Strong Floor Interference and Working Space

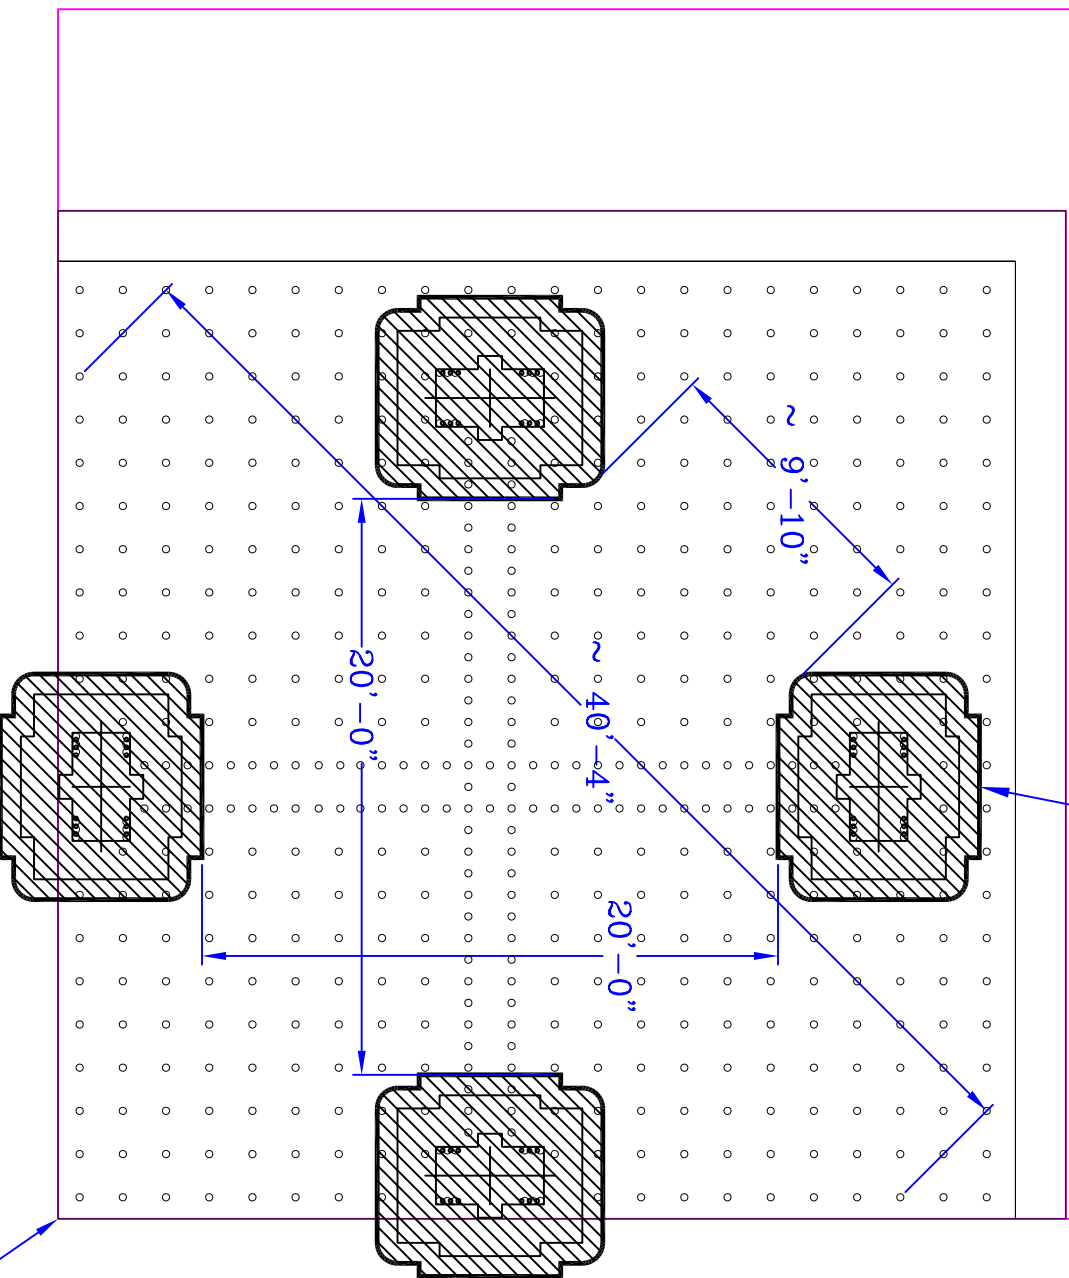
Potential interference with
MAST 6-DOF Vertical
Actuators in this area
